FILE NUMBER: 18-DP-22

SUBJECT: Site Plan Review for a 20 unit residential development (Roosevelt Apartments).

APPLICANTS MUST ADDRESS ALL COMMENTS AND FINDINGS AS IDENTIFIED BY MEMBERS OF THE TECHNICAL ADVISORY COMMITTEE BOTH IN WRITING (IDENTIFY PAGE NUMBER OF THE CORRECTION) AND ON THE SITE PLAN (ALL CHANGES MUST BE IDENTIFIED, I.E. BUBBLED).

PROPOSED 20 UNIT MULTI-FAMILY DEVELOPMENT FOR:
 XLT INVESTMENT CORP.
 16450 NE 35 AVE.
 NORTH MIAMI BEACH, FLORIDA.

A-2.3
OF SHEETS

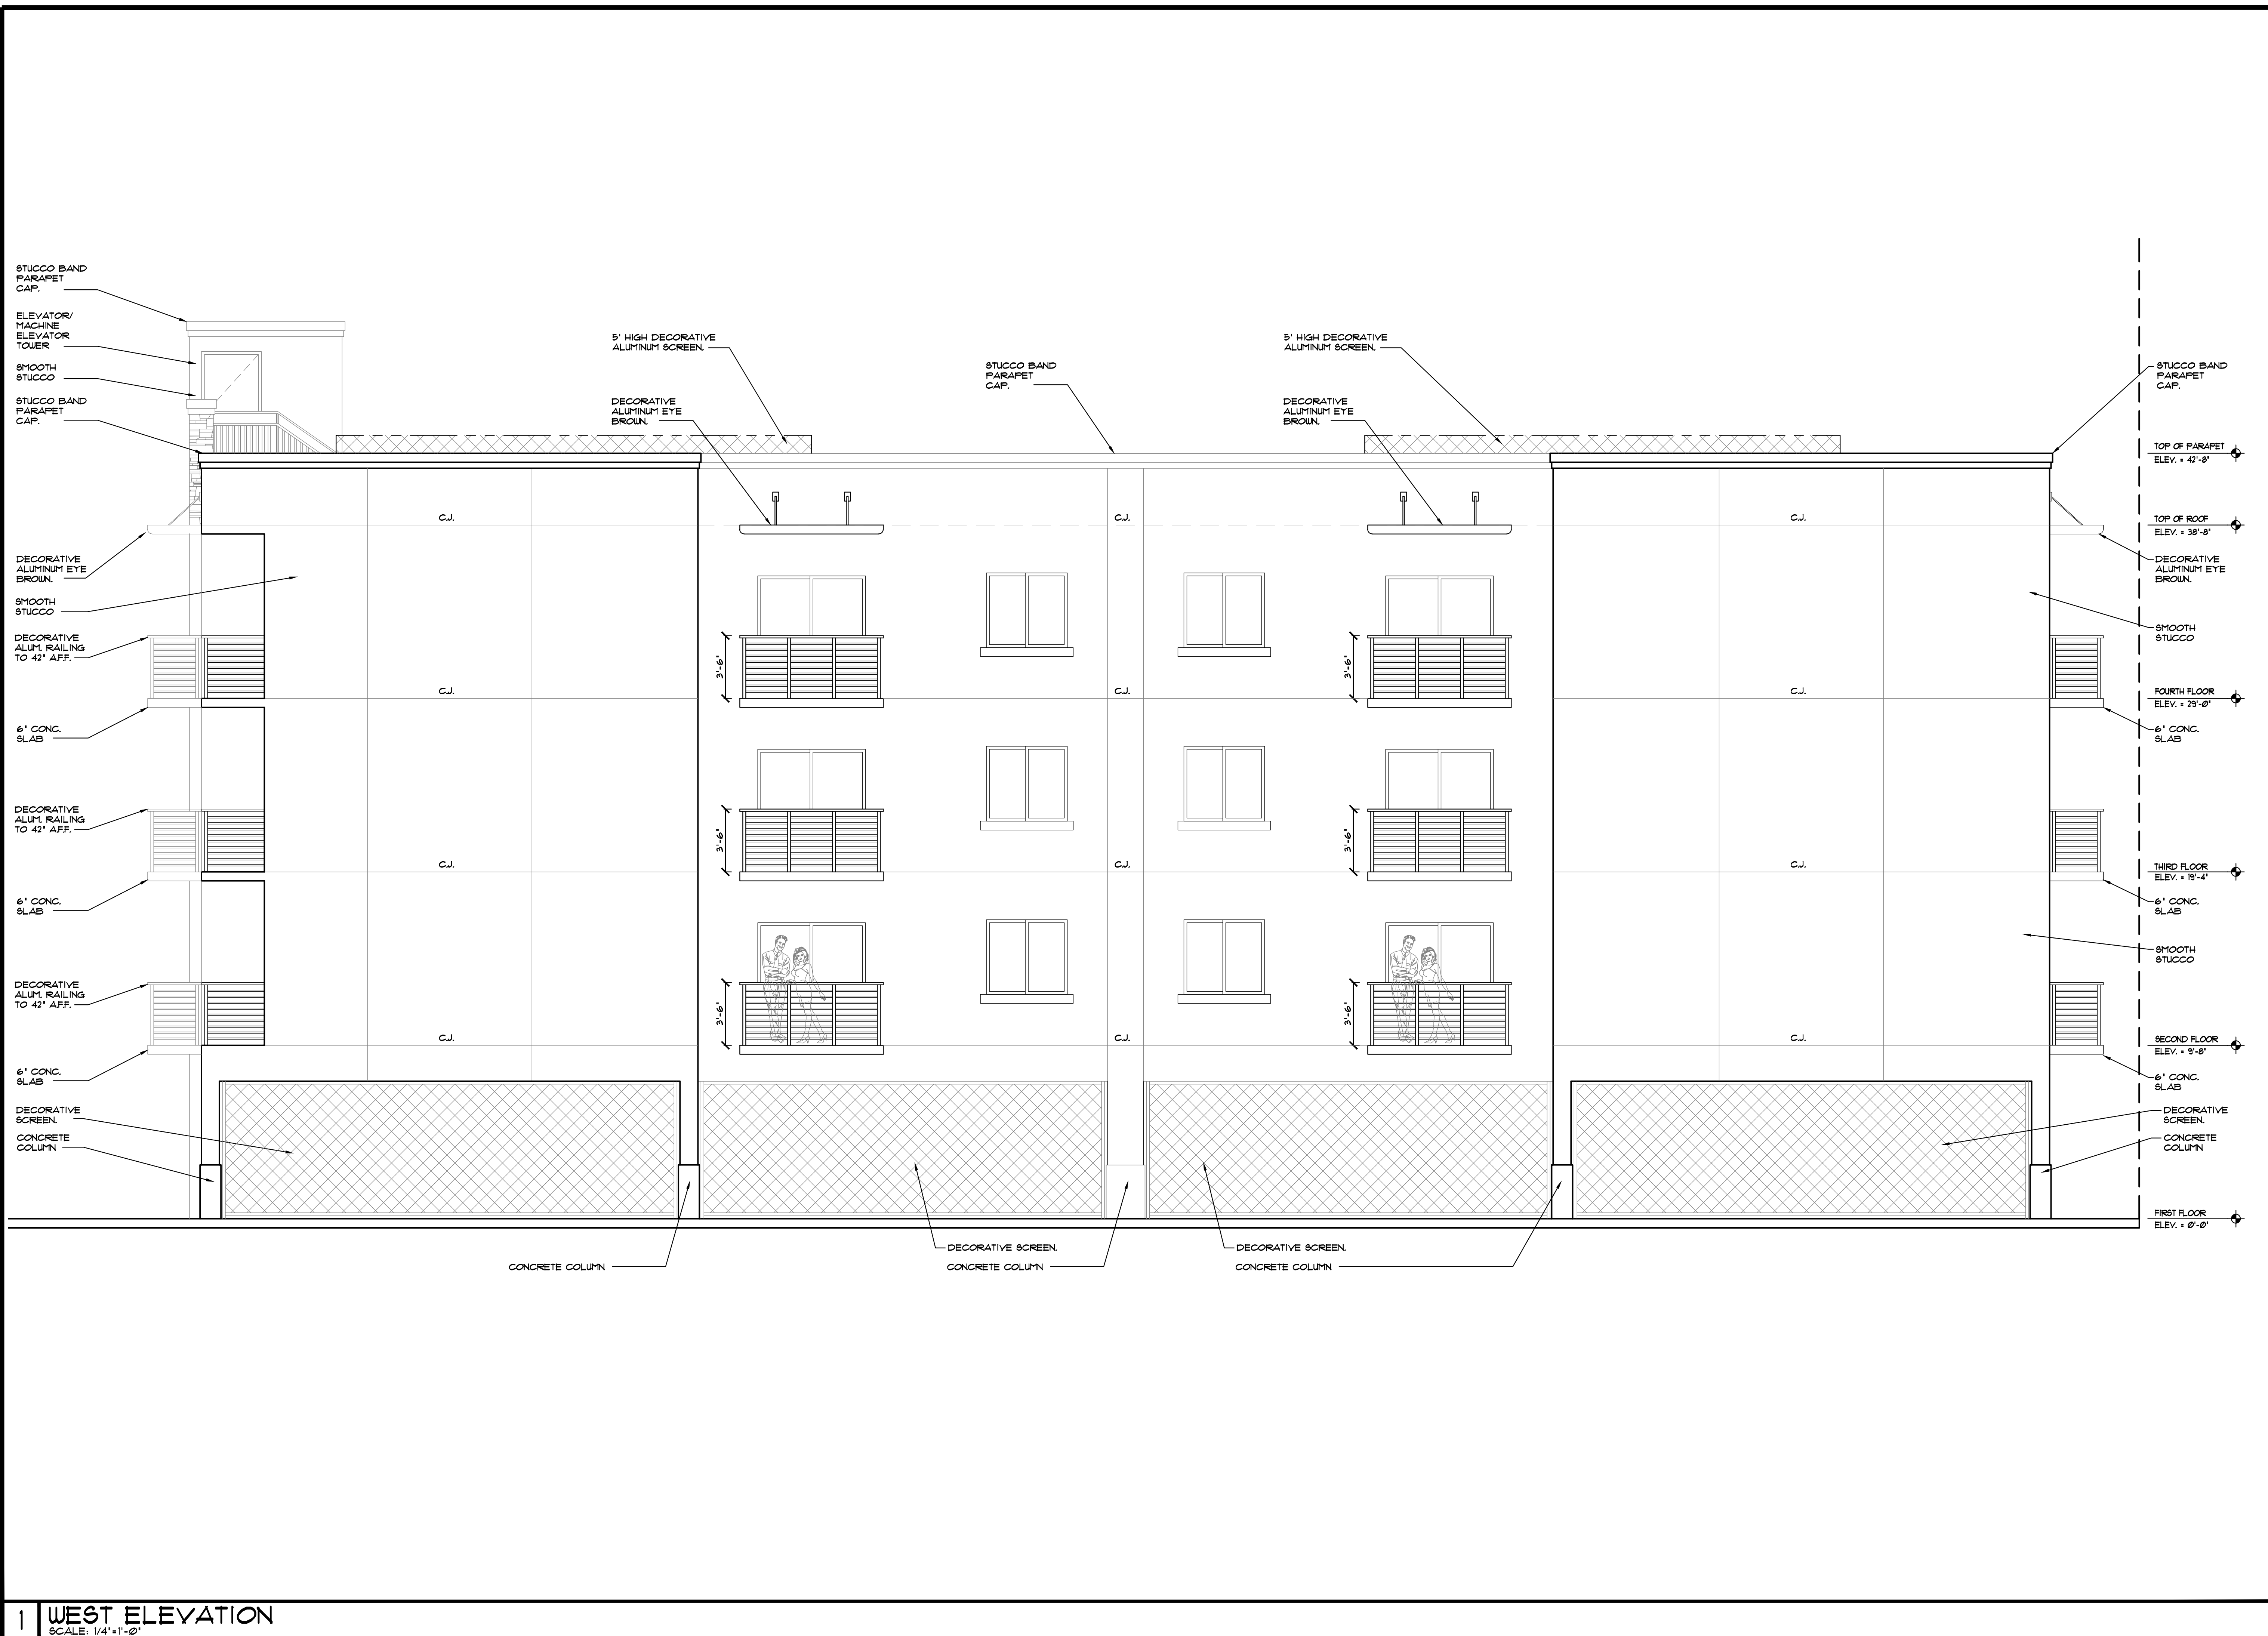
7. Sheet A-2.3 – What is the “C.J.” label?

Response: control joint

1 PROPOSED PAVING, GRADING, WATER & SEWER PLAN
 SCALE: 1"=10'-0"

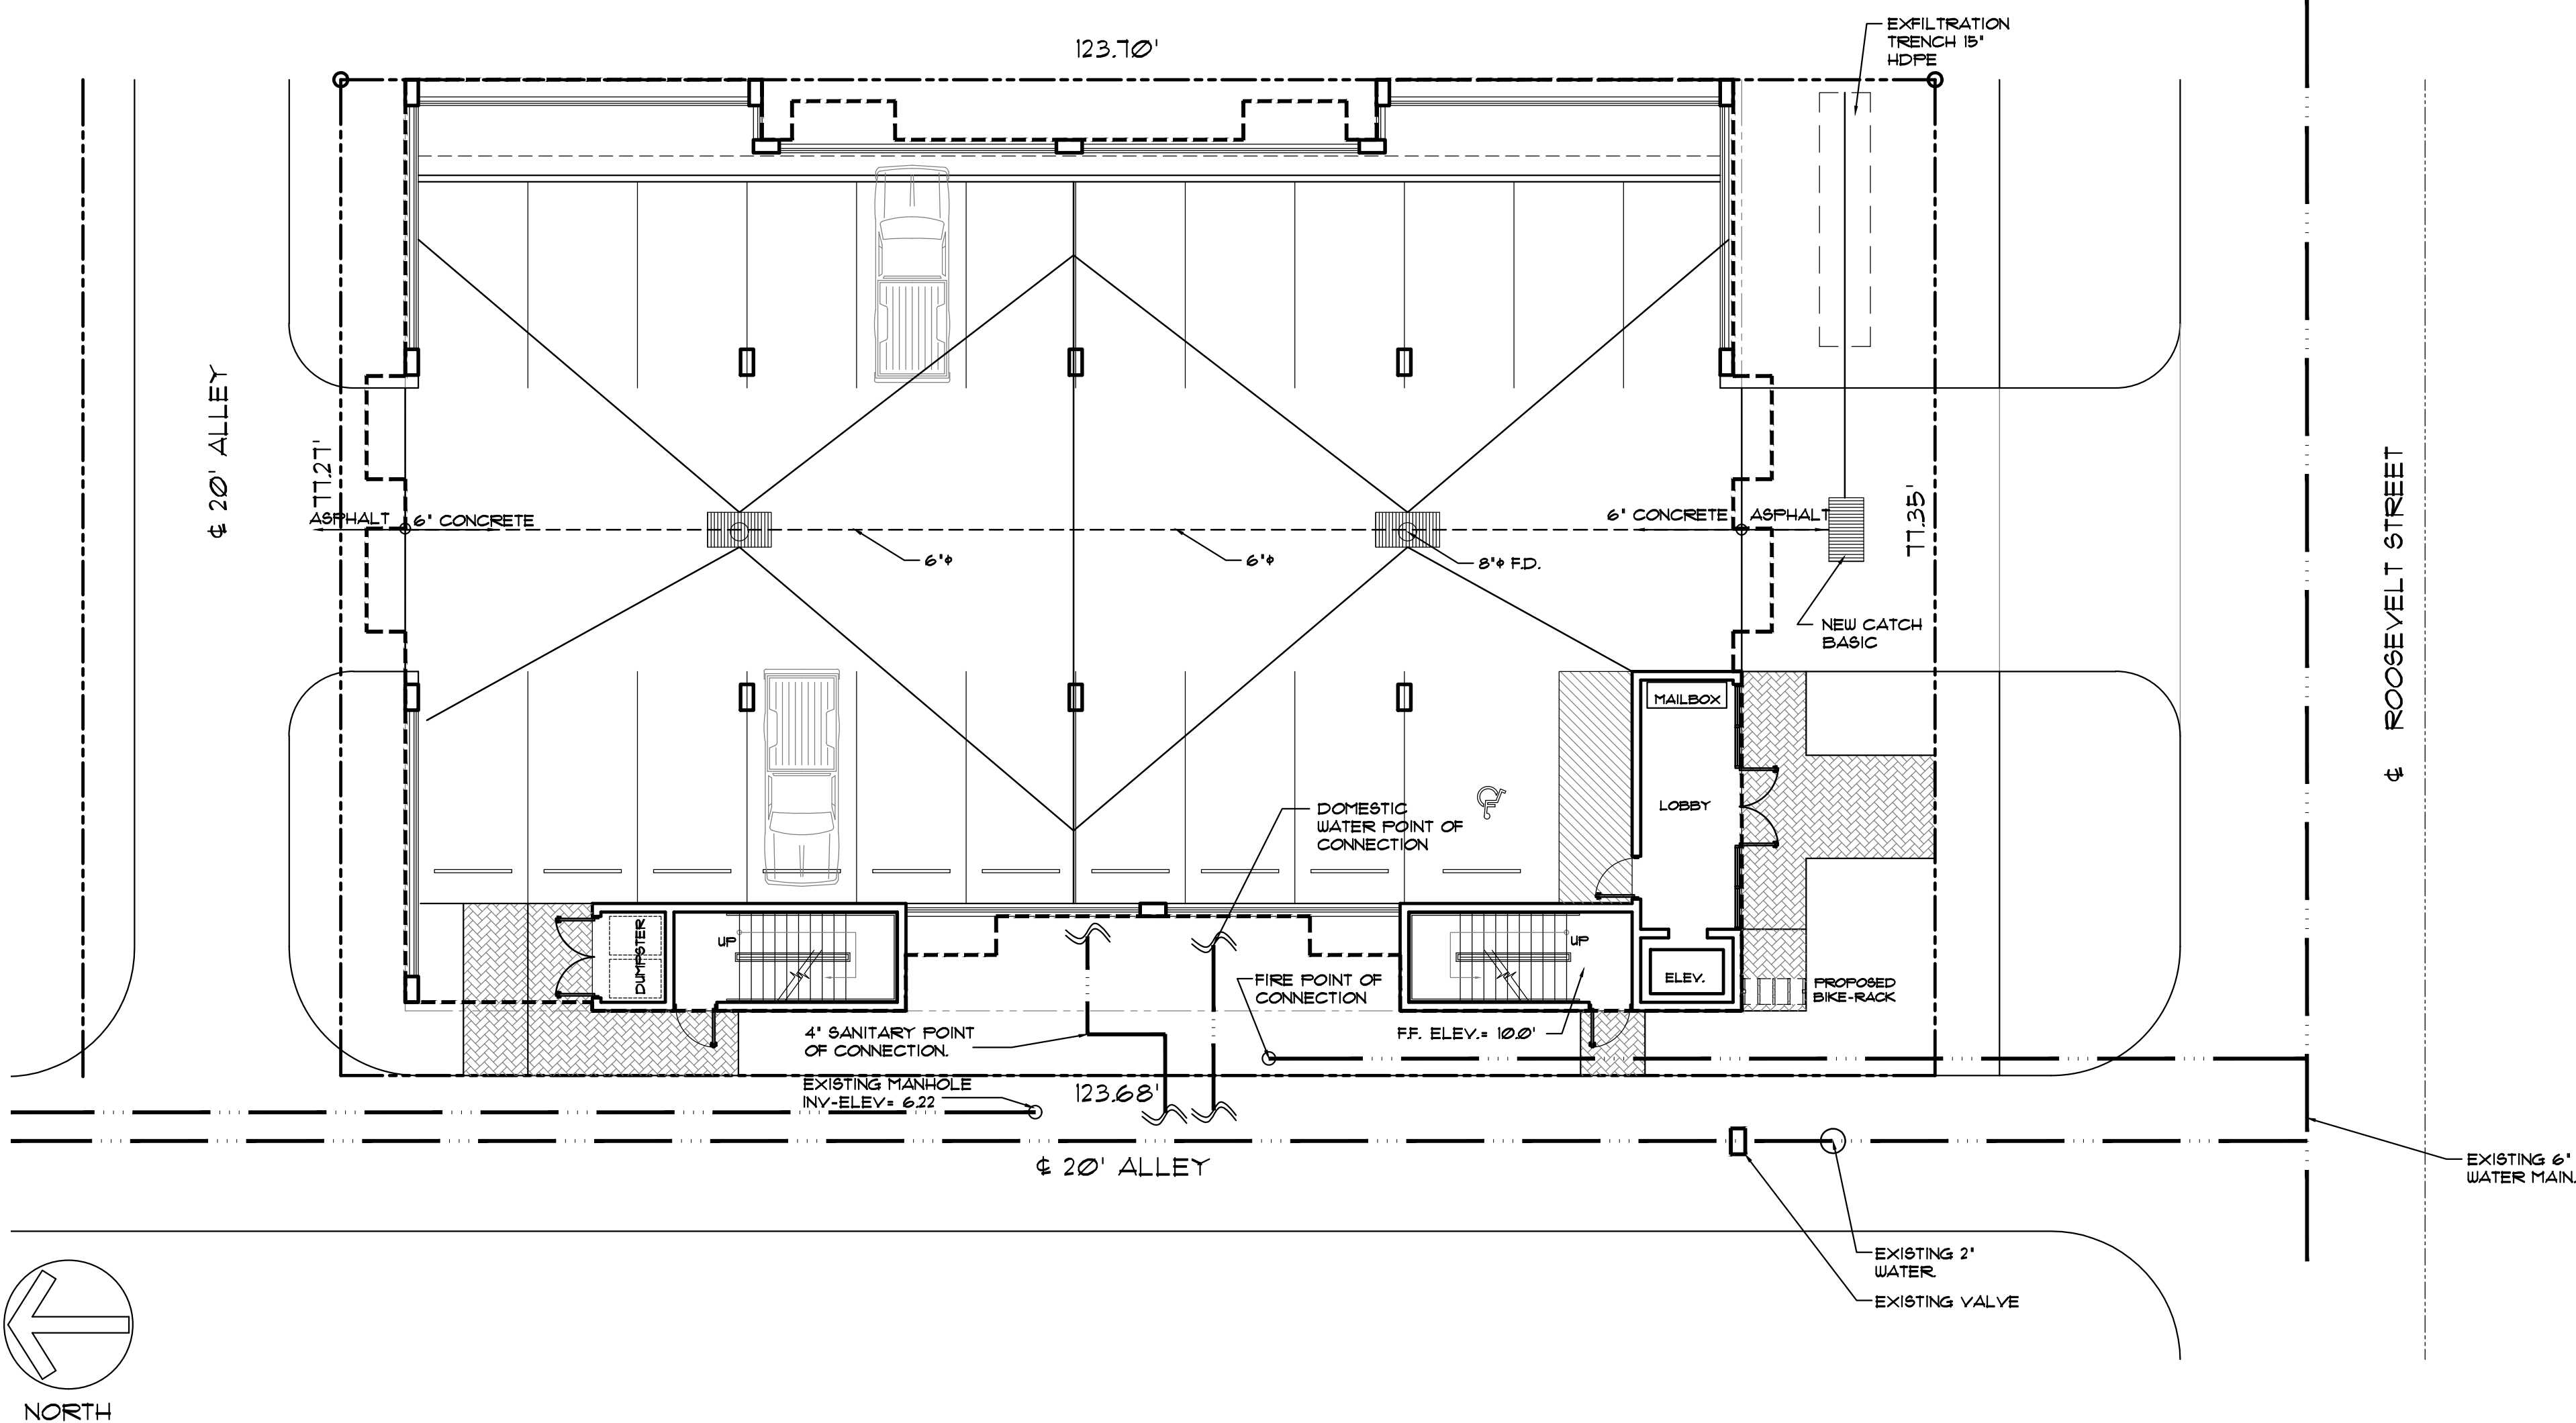
7. Provide civil plans for the proposed work. Include items such as drainage improvements, water and sewer connections, curbing, all vehicle turning radii (provide sufficient vehicle turning radii for trash trucks at the alleys), sight triangles and details as well as change in elevations to show that handicap accessibility has been met. For water and sanitary sewer connection, show any pavement restoration and details required for connections within City rights-of-way. With the level of construction activities necessary for the proposed development, full road width pavement resurfacing abutting to the site (adjacent alleys Roosevelt Street) will be necessary, please indicate on civil plans.

Response: Refer to Sheet C-1
